S.P. 1308.29 TH 8 IMPROVEMENT PROJECT (HIGHWAY 8 - LET'S GET MOVING)

VALUE ENGINEERING REPORT

Chisago County, MN

SEPTEMBER 2020

Exhibit P1.3: As Given Typical Section

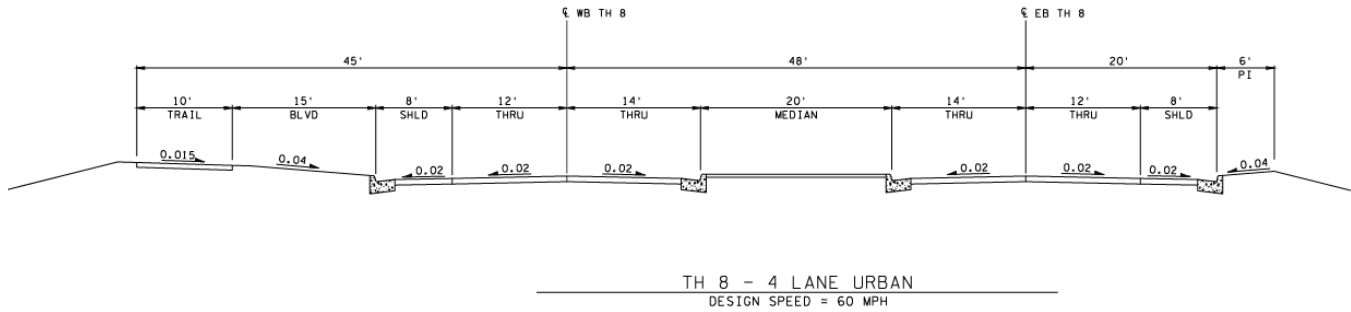
East of TH 61 to STA 876+00 (Lake Ellen/ Little Green Lake), TH 8 is proposed to be reconstructed as a four-lane divided urban roadway with a design speed of 60 mph. The inside travel lane will be 14 feet wide to face of curb, the outside travel lane will be 12 feet wide, and the outside shoulder will be 8 feet wide to face of curb. Traffic will be separated by a 20-foot-wide paved center median. A 10-foot-wide shared use trail will be built on the north side of TH 8, with a 15-foot boulevard between it and the edge of the outside shoulder. See Exhibit P1.3 for the As Given typical section.

Exhibit P1.4: As Given Typical Section in Constrained Area

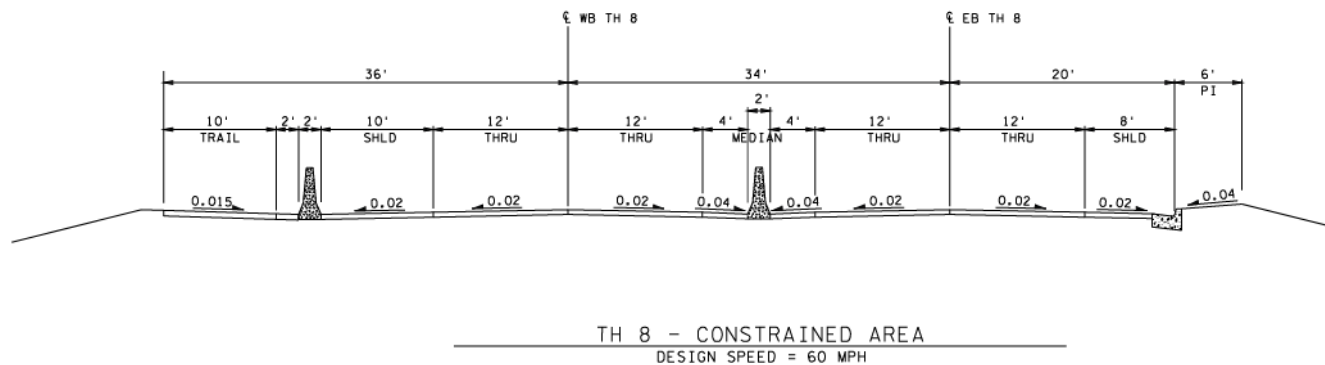
In the constrained area between Comfort Lake and Little Comfort Lake, an alternative typical section is proposed, replacing the 20-foot-wide center median with a 10-foot median with barrier wall. The north side shoulder is also replaced with a 10-foot shoulder and barrier wall immediately adjacent to a 12-foot shared use trail.

Exhibit P1.6: 45 mph Urban Typical Section

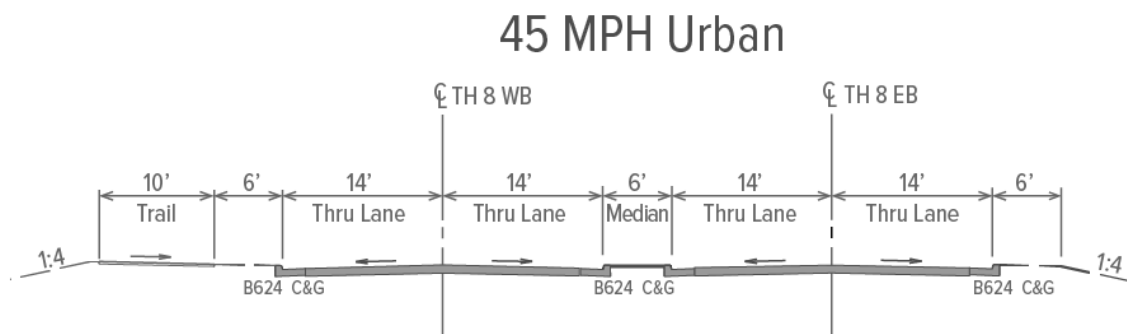
Modify the design speed to 45 mph and use low speed environment geometrics for a four-lane divided roadway. Travel lanes will be 14-feet-wide to face of curb, and the raised median will be six-feet wide. The shoulders will be eliminated. Reduce the buffer space between the back of curb and the shared use trail to six feet. See Exhibit P1.6 for the modified typical section.

Exhibit P1.7: 50 mph Hybrid Urban Typical Section

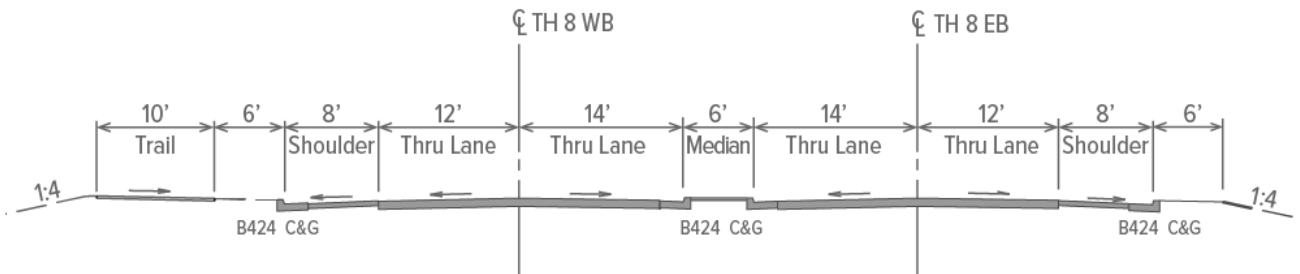
Modify the design speed to 50 mph and use modified geometrics for a four-lane divided roadway. The inside travel lanes will be 14 feet wide to face of curb, the outside travel lanes will be 12 feet wide. The raised median will be 6 feet wide. The shoulders will be 8 feet wide to the face of curb. Reduce the buffer space between the back of curb and the shared use trail to 6 feet. See Exhibit P1.7 for the modified typical section.

Exhibit P1.8: 50 mph Hybrid Urban Typical Section

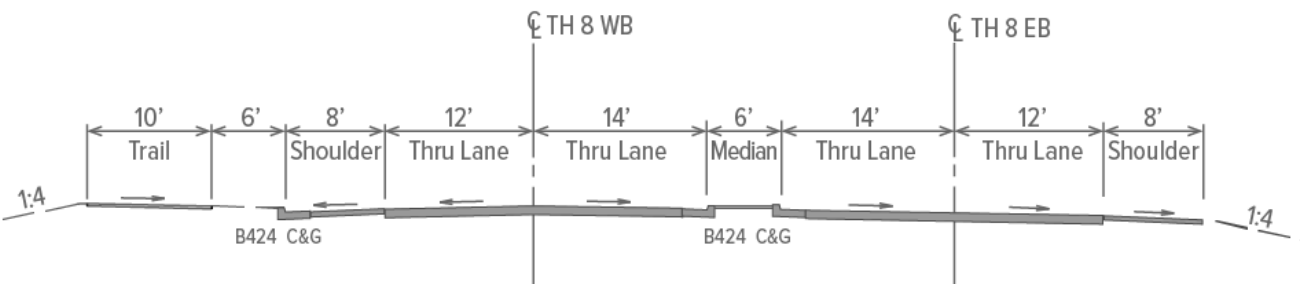
Modify the design speed to 50 mph and use modified geometrics for a four-lane divided roadway. The inside travel lanes will be 14 feet wide to face of curb, the outside travel lanes will be 12-feet wide. The raised median will be six-feet wide. The north side shoulder will be eight feet wide to the face of curb, and the south side shoulder will be eight-feet wide without curb and gutter. The south side will also feature unidirectional pavement, eliminating the need for storm sewer structures and pipes. Reduce the buffer space between the back of curb and the shared use trail to six feet. See Exhibit P1.8 for the modified typical section.

Exhibit P2.5: VE Proposal P2 - TH 8 & Greenway Avenue intersection

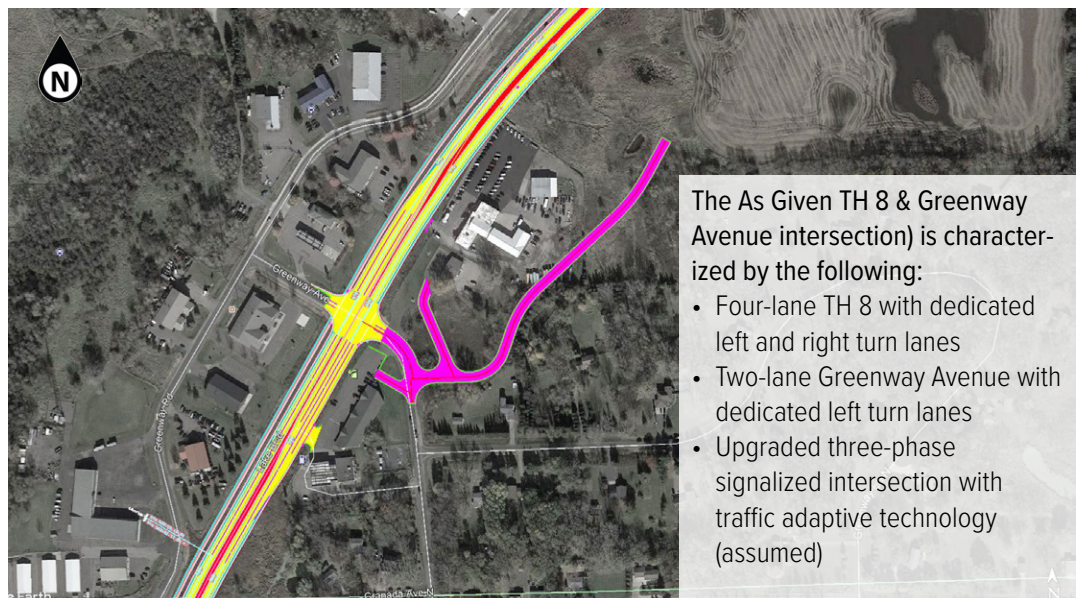
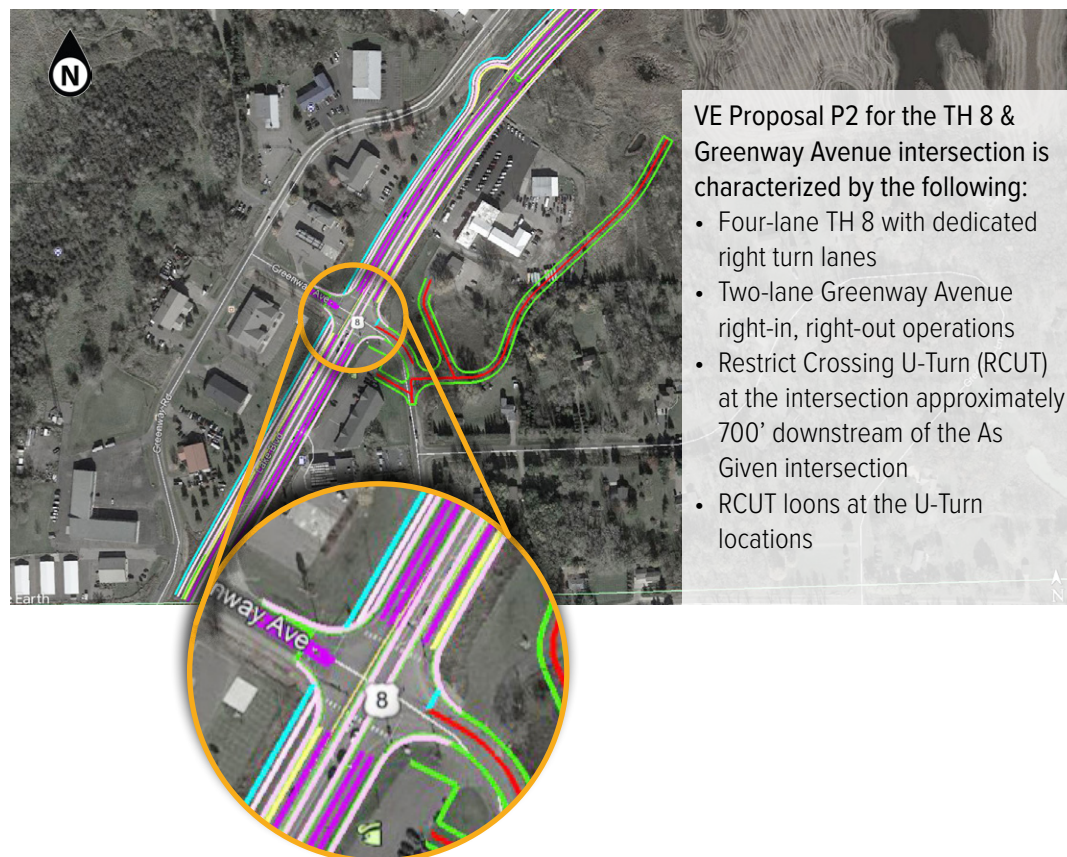
VE Proposal P2: RCUT at Greenway Avenue

Exhibit P5.7: Typical RCUT proposed for James Avenue / Juno Court

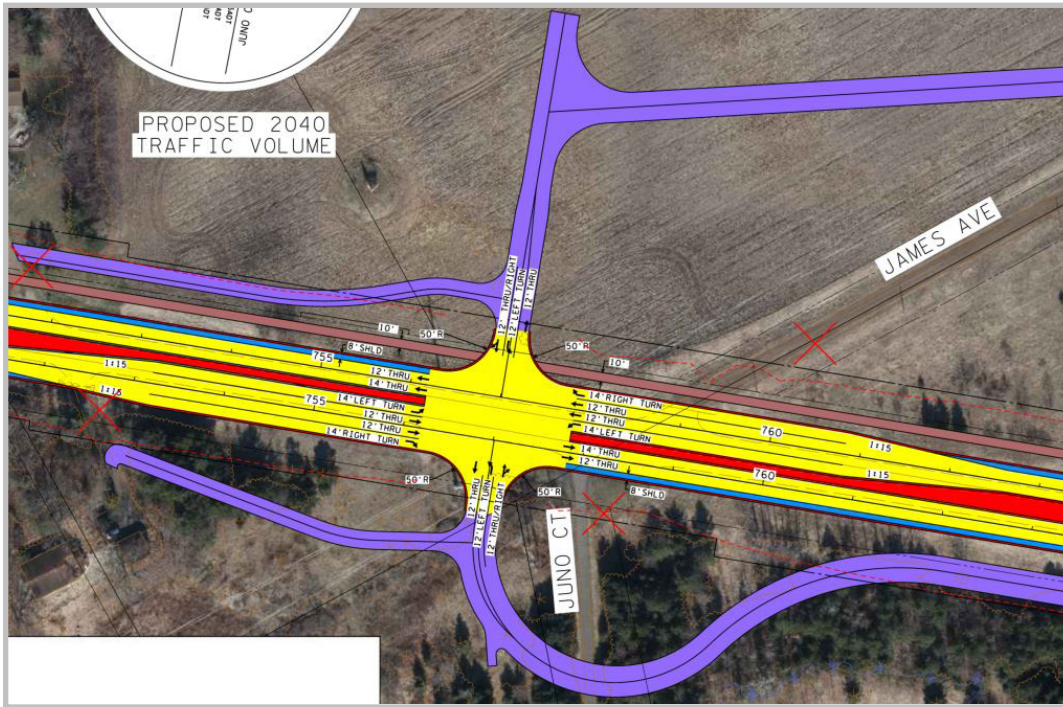
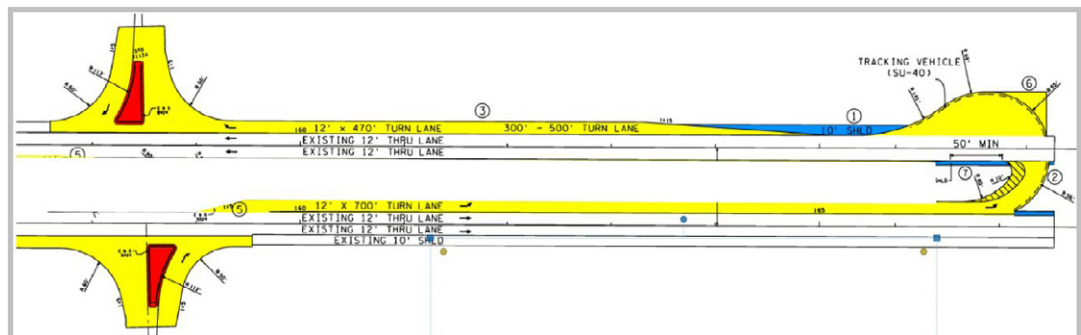
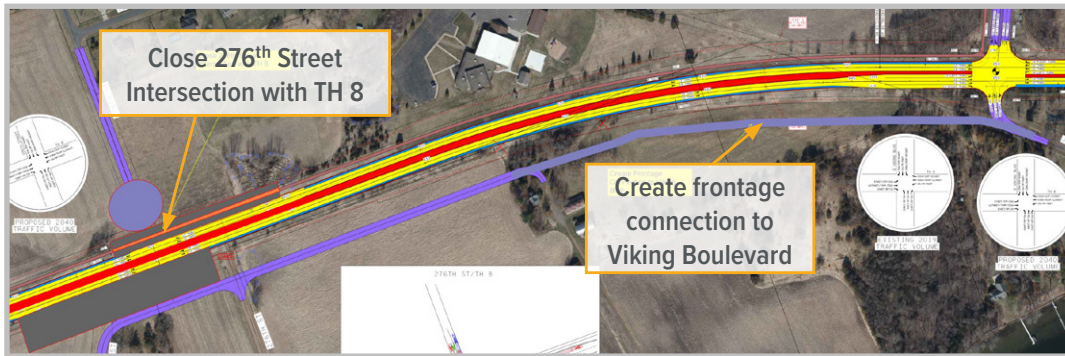
The VE proposal is to improve the intersection spacing, balance and manage local intersection connections by installing an RCUT at the James Avenue / Juno Court intersection and remove the 276th Street intersection. Eliminate the access road from the private property at approximately STA 835+00 and allow right in / right out access to TH 8. This meets current MnDOT access management approaches for intersection spacing and reduces the risk of severe right-angle crashes. Additional construction of access to TH 8 would still be available at James Avenue / Juno Court and Viking Boulevard Intersections. See Exhibits P5.6, P5.7 and P5.8.

Exhibit P6.5: RCUT at TH 8 and Viking Boulevard

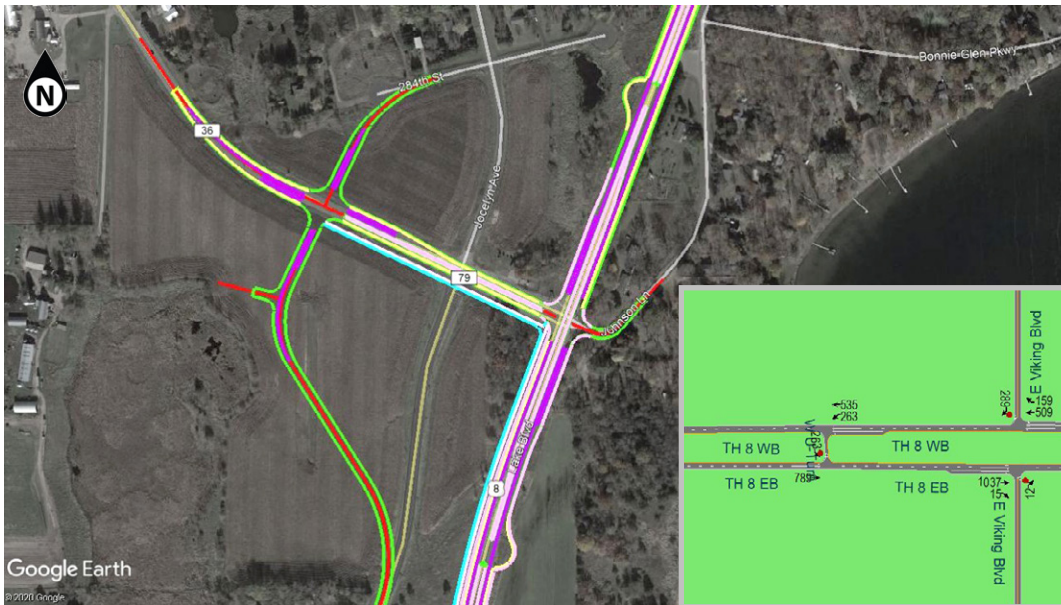
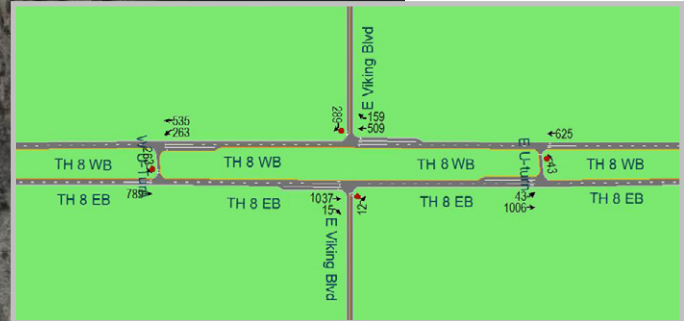
Restrict the Viking Boulevard thru movement and install an RCUT along TH 8. This would create four, two-way stop controlled intersections with a 2040 PM peak Level of Service of A. See Exhibit P6.5 for the Viking Boulevard intersection RCUT, and Exhibit P6.6 for the traffic volume distribution.

Exhibit P7.5: VE Proposal TH 8 & Greenway Avenue intersection

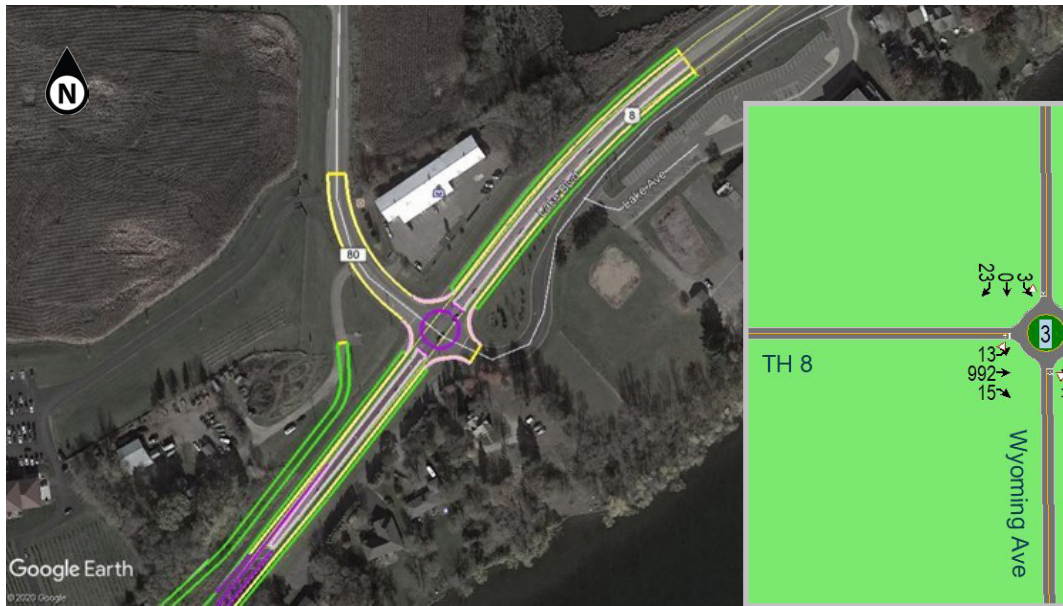
- Two-lane TH 8
- Two-lane Karmel Avenue
- Roundabout operation with 115-foot inscribed diameter

Exhibit P8.5: Eastbound TH 8 from I-35 to TH 61

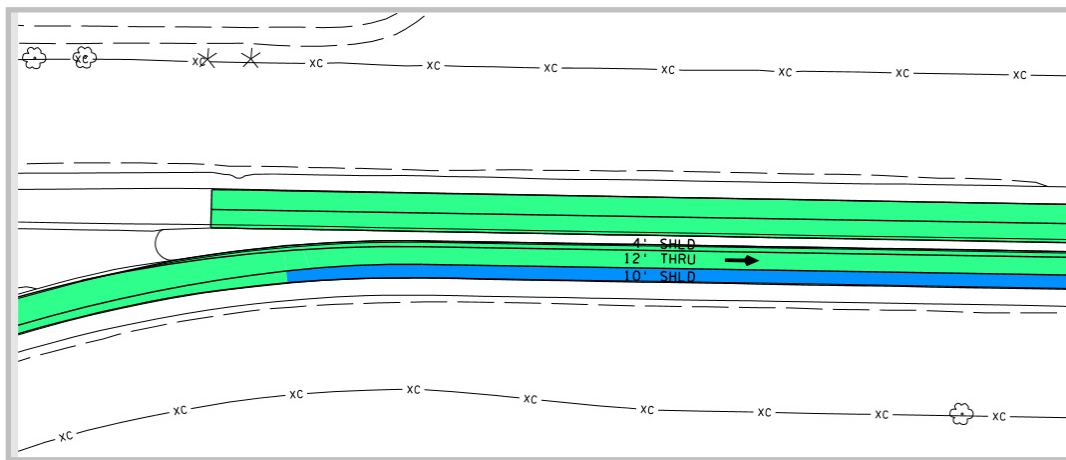
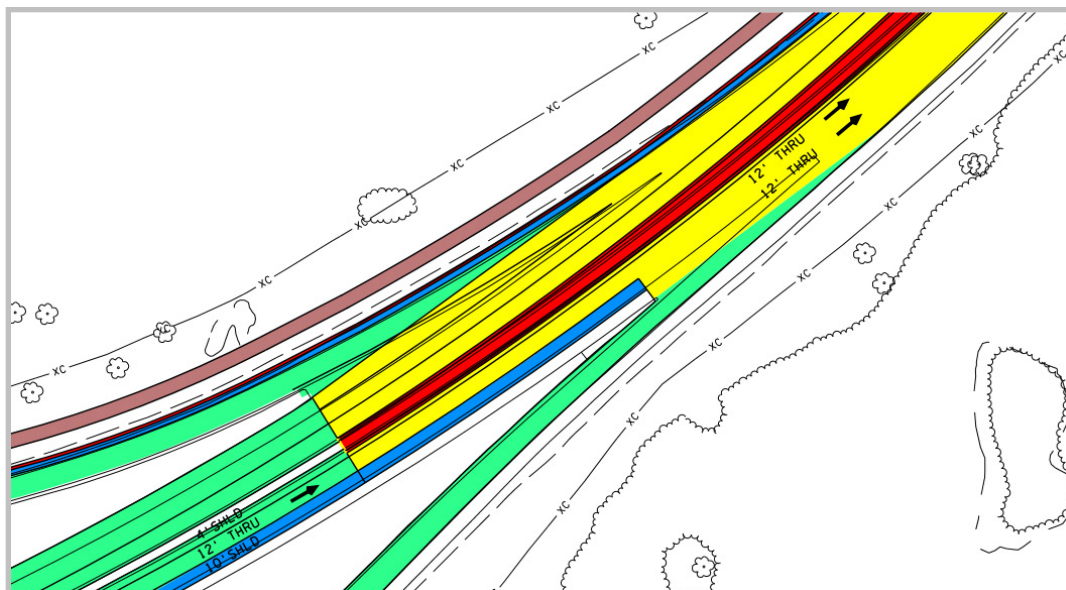
Resurface and re-stripe eastbound TH 8 from I-35 to the TH 61 eastbound on-ramp to one lane with a wide outside shoulder. See Exhibits P8.5 and P8.6. The eastbound TH 61 on ramp to TH 8 will add the second lane.

Changing the current eastbound freeway segment to a one lane facility will improve safety and traffic flow from TH 61 to Greenway Ave. The current one lane off-ramp from Northbound I-35 to TH 8 would continue to TH 61. The ramp from TH 61 northbound and southbound would remain the same and become a lane add and begin the eastbound TH 8 future four lane section. The on-ramp to TH 8 from TH 61 would remain in its current configuration with either a parallel or tangent on-ramp design.

This modification would reduce conflict in the merge area approaching the Greenway intersection and local access drives at the point where the road currently transitions from a high-speed freeway section to full access arterial design. It would also help slow approach speeds and aggressive behaviors due to conflicting design messages to drivers.

Exhibit P9.4: Mini-Roundabout on Greenway Ave N

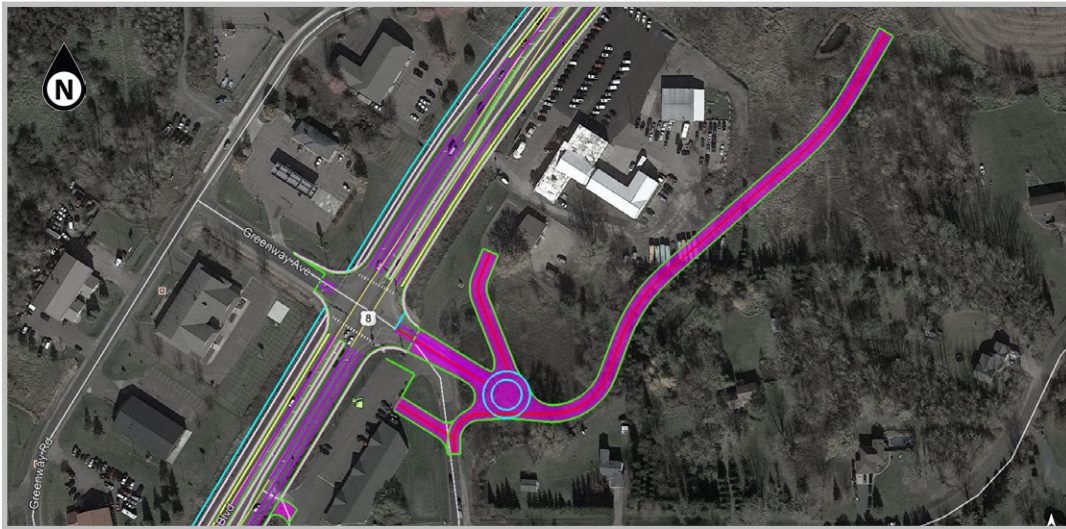
Proposal P9 focuses on the local road improvements east of TH 8 and maintains the As Given condition along TH 8. The two closely spaced intersections that were proposed in the As Given design would be combined into one roundabout with a 90-foot inscribed diameter with a fully traversable central island. The leg of Greenway Ave intersecting with TH 8 would be realigned to be perpendicular to TH 8, which will add storage length for turning movements. Right-In-Right-Out driveway at the business on the southeast corner from TH 8 would be modified to be Right-In only. See Exhibit P9.4 for the Proposal P9 Mini-Roundabout on Greenway Ave N.

Exhibit P10.4: Proposal P10 Cross Section

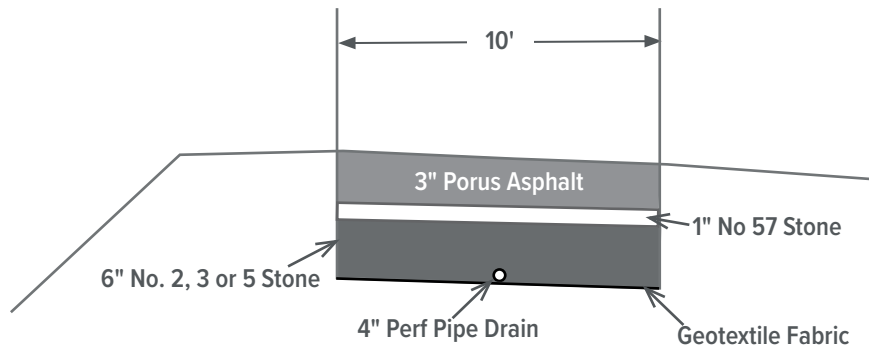
Construct separated, 10' trail with porous asphalt. See Exhibit P10.4 for proposed cross section.

Exhibit P11.5: Proposed ending of four lane section east of Pioneer Road.

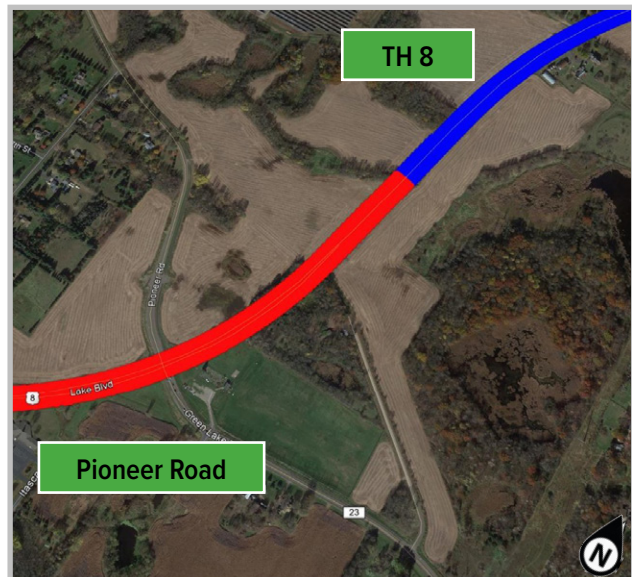
A significant portion of the new construction east of Pioneer Road is for attracting new development in the area. If construction is deferred to a later time, these new developments can share in the cost of improving the infrastructure in the corridor from Pioneer Road to Karmel Avenue. Should funding become an issue for this project, this is a solution the project team can consider.
